Chapter 4

Comment Documents and Responses on the *Supplement*

This chapter presents scanned images or transcriptions of all oral or written comments submitted to DOE on the *Supplement*, with the DOE responses. In most instances, the response appears on the same page as the corresponding comment. Where many comments appear on a single page, however, the responses may extend to succeeding pages. The comments and responses are presented in the following order:

MR012

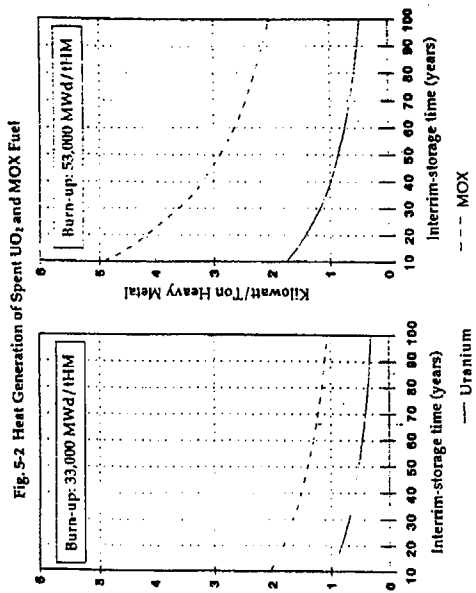
I reference the International MOX Assessment report entitled the Comprehensive Social Impact Assessment of MOX Use In Light Water Reactors by J. Takagi et al., 1997 by Pub. Citizens Nuclear Information Center, Tokyo, Japan. page 190 shows the following table for decay heat generation is presented:

Higher heat generation means MOX fuel must be stored in the cooling ponds longer and will generate more heat in a repository. I add that higher fissile material concentrations in spent MOX fuel will also be higher creating a greater criticality danger.
